The New T41 V12.8 Boards.

What's new… and why the change from V12.7?

April 25, 2026

Pictures are priceless. The Figure below is a picture of a completed V12.6 board.

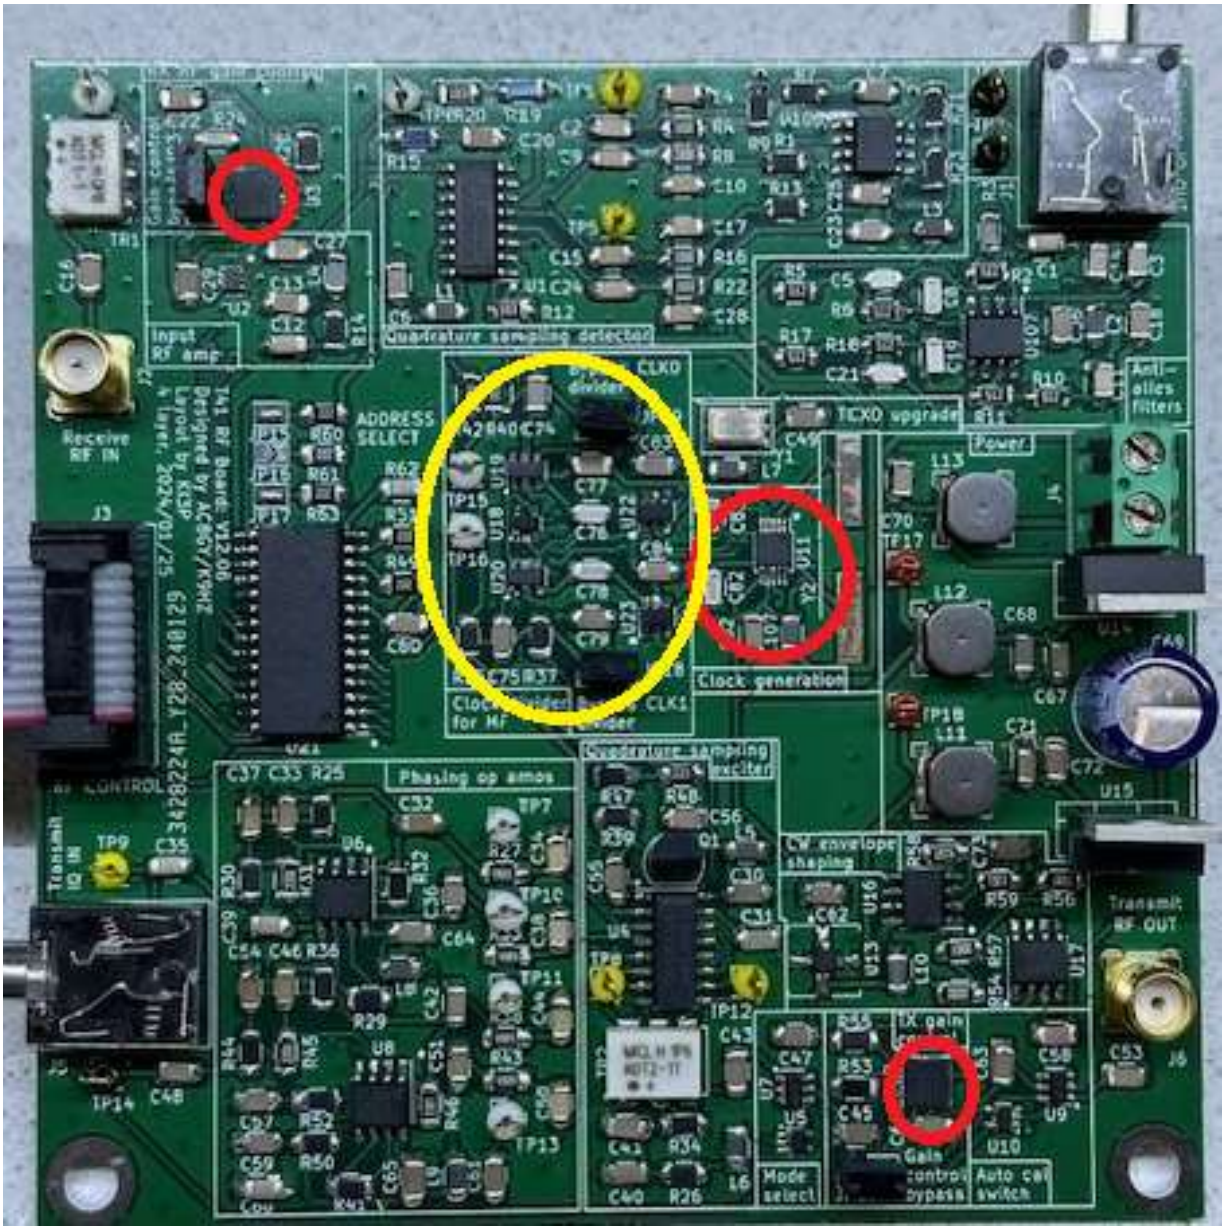
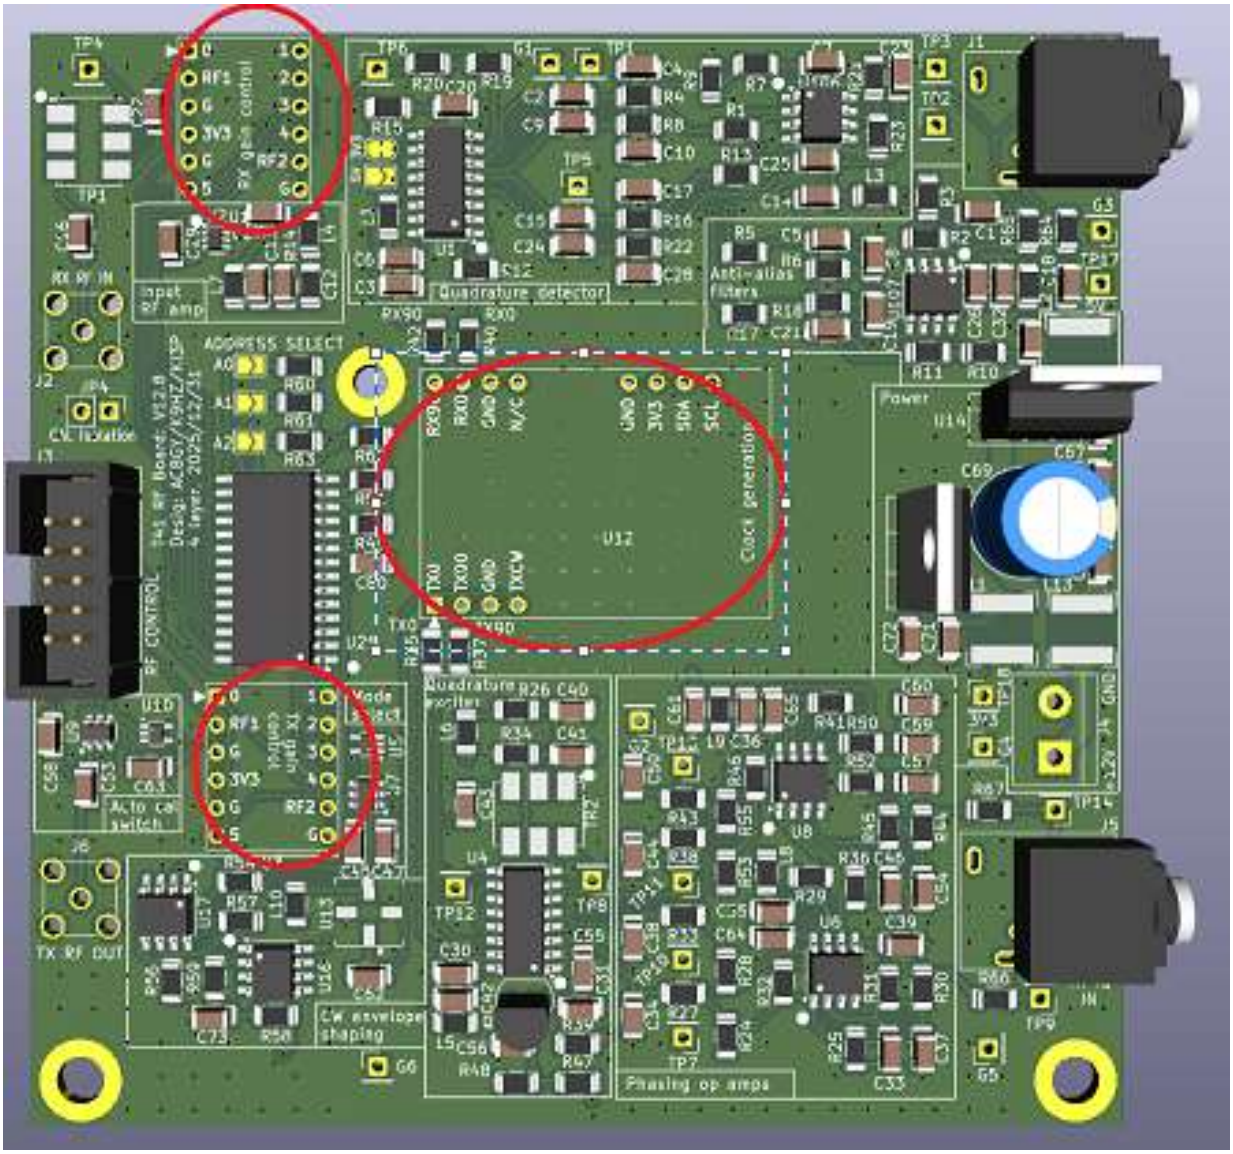
We got a lot of feedback from people building the V12.6 and V12.7 RF board that it was very difficult to mount the PE4212 attenuators (one for receive and one for transmit) on the board due to the small part size (QFN part) and need for hot air solder tools to adequately solder the parts. In addition, we realized that the existing Si4241 clock wouldn't allow for an auto-calibrate cycle where the receiver and transmitter (on the RF board) were both active at the same time (when the calibration cycle can be completely automated). To address these issues… essentially make the T41 V12 radio better, we decided to: 1) move these parts these parts to DIP-sized daughter boards that could be (sold) pre-made and easily added by the builder by adding IDC pins, and, 2) change to the si5351A-B-GM that has EIGHT separate oscillator outputs…. enough to generate a clock quadrature pair for the receiver, a pair for the transmitter, and one for CW (with three to spare!). That allows the receiver and the transmitter to be on simultaneously, and the calibration process to be automated. Simply solder some IDC pins on these small daughter boards… solder IDC sockets to the V12.8 RF board, and plug in the daughter cards.

The two PE2312 attenuators and the si5351 oscillator are shown inside the red circles on the board. The MF circuitry in the yellow circle was also removed from the new V12.8 board because we were able to do this in software and simplify the hardware.

The new V12.8 board looks like this (module locations in red circles):

The picture clearly shows the main spot where the main oscillator daughter board goes in the center of the board, and the two places where the attenuator modules go. The new pre-made modules to go into those spaces and look like this:

Single attenuator module: **AND/OR** **The dual attenuator module:**

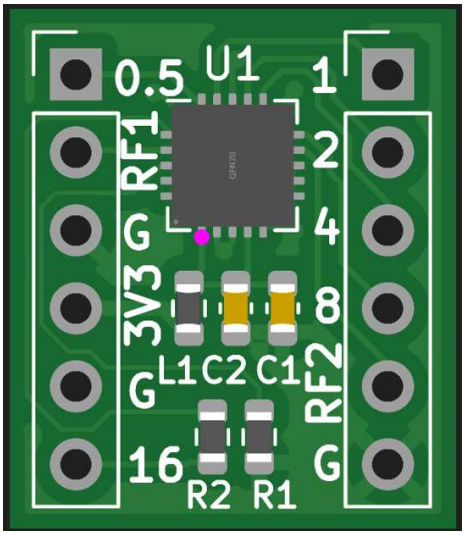
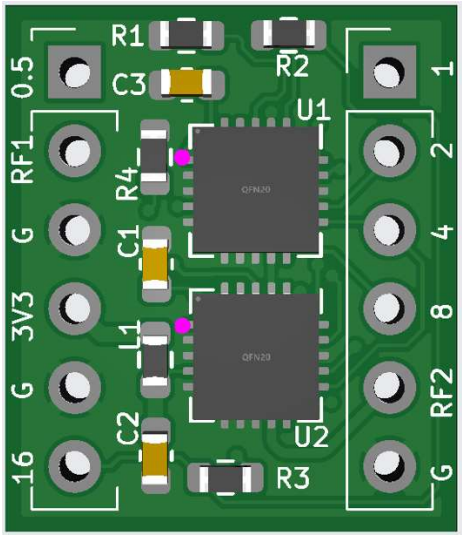
This approach also allows some additional experimentation with the attenuators and oscillator. We've already designed a new twin attenuator board that has two PE4312 chips on it in series that gives a total of 63.5 db of attenuation in 1 db steps instead of the original 31.5 db in 0.5 db steps. This is nice for building an automatic hardware AGC for receive, and for having range in the output power control on transmit. A replacement for the oscillator board could be made using a high precision oscillator like the si5340 that is capable of a much greater frequency range, and more precise native quadrature generation. I suspect we will see some additional creativity as time goes on.
